An Existential Threat to Holy Trinity Monastery and Seminary

Figure 21B
PHOTO SIMULATIONS
Sickler Road Wind Energy Project
Town of Stark, Herkimer County, NY

Photo 20 - Overlook near Holy Trinity Monastery
EXISTING CONDITION

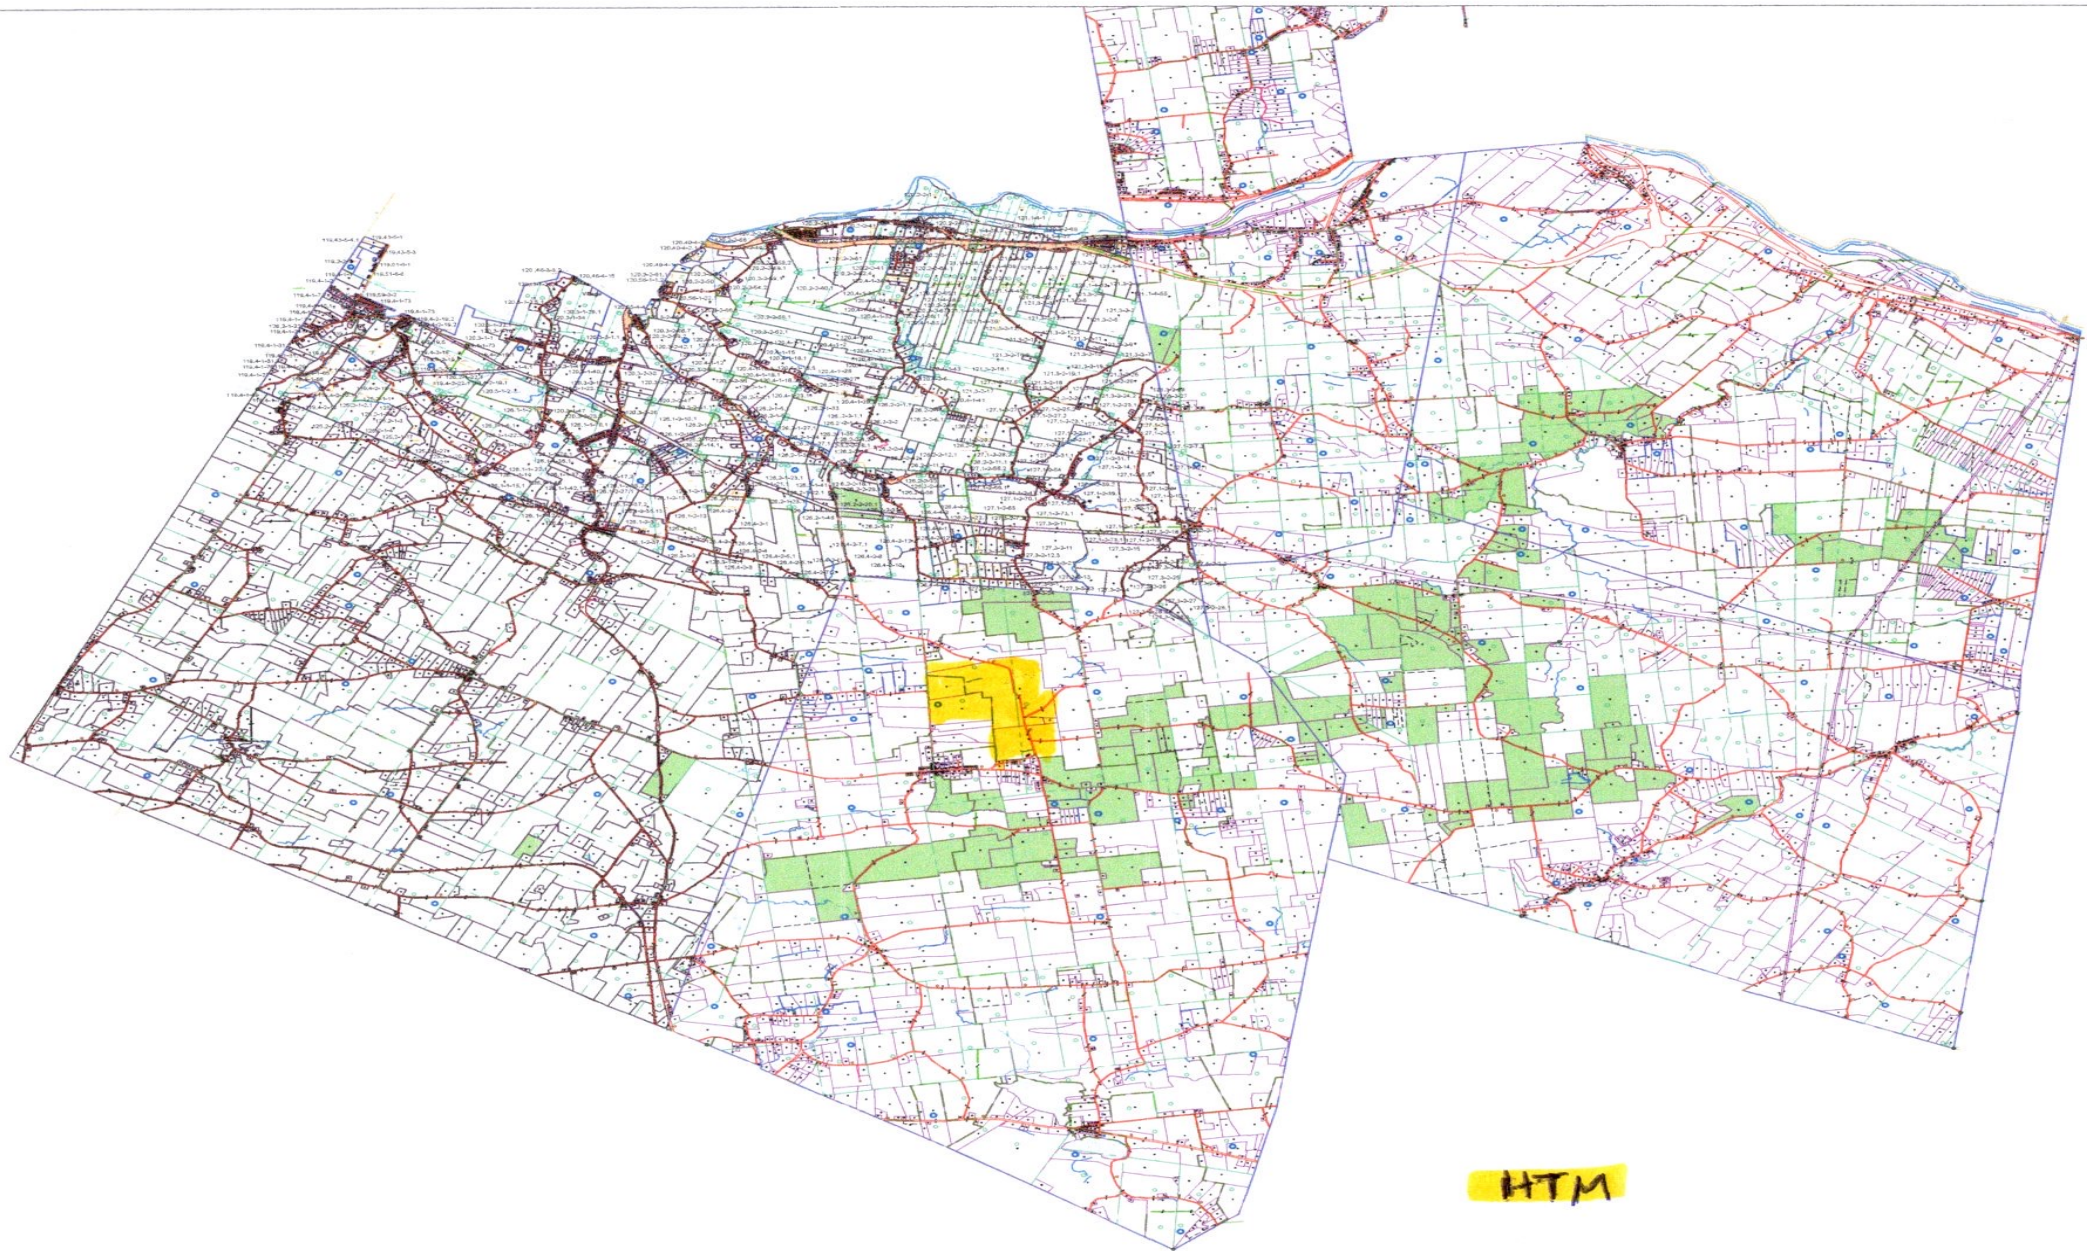
- The visual simulation, as seen from Golgotha, has a sharpie highlighting the view. As noted by both Otsego 2000, and the Preservation League of New York state: “To state, as the January 2024 visual impact analysis does, that because the turbines are behind the monastery buildings when looking east from Hilltop Cross and therefore don’t ‘obstruct’ the view of the historic properties, is to completely ignore the importance of the Monastery’s very intentional siting within its landscape,” and, “For the Holy Trinity Monastery, the impacts are particularly deleterious. Its nomination to the State and National Registers calls out the Monastery’s 750 acres, and its larger context which is characterized by rolling hills, open lands, agricultural fields, and ridgelines. For its purposes as a monastery and teaching seminary, these landscape features, along with the landmark buildings, are intentional and have been sustained since the Monastery’s founding in 1928. They have been renewed with additional land acquisitions and monastic building construction, the latest being the 1988 bell tower. Much of the Monastery’s activity is focused on the sacred east, which is reinforced by the positioning of the three cemeteries, prayerful contemplation at the outdoor crosses, and the services indoors.”

- Golgotha is at an elevation of 1689 feet above sea level and is the highest point between the Stark Project and the Monastery. Therefore, 586 feet of tower 1 and 606 feet of tower 2 will be visible on the horizon

It is clear from the simulations presented in the Visual Impact Analysis that the proposed wind turbines are visible from the National Register of Historic Places listed Holy Trinity Russian Orthodox Monastery (Monastery). The Monastery is a unique cultural and religious site that includes highly significant landscapes, buildings, and artwork of National significance that continues to be used by the descendant community. One of the landscape features is the three-bar Cross (Hilltop Cross). The Hilltop Cross is used regularly for prayer with worshipers traditionally facing east, which is the direction of the proposed wind turbines. The National Register nomination notes that the location of the Monastery was chosen because the rolling high plain landscape of Jordanville is reminiscent of the sub-Carpathian Russia, the original home of this monastic community. Within this open, rural setting, the Holy Trinity monks actively preserve cultural traditions and practices of the ancient Russian Orthodox Church by living a traditional monastic life of seclusion, prayer, and study. The naturalistic setting was deliberately chosen and is inextricably linked to the history, cultural practices, and religious views of this Russian Orthodox community. Given this background, it is the finding of the OPRHP that the project will have an Adverse Impact on the National Register of Historic Places listed Holy Trinity Monastery. Please note that vegetative screening is not considered by the OPRHP to be an effective minimization measure because of the height of the towers. Therefore, the OPRHP strongly recommends that the two proposed wind turbines are relocated so they are not visible from any portion of the Holy Trinity Monastery.
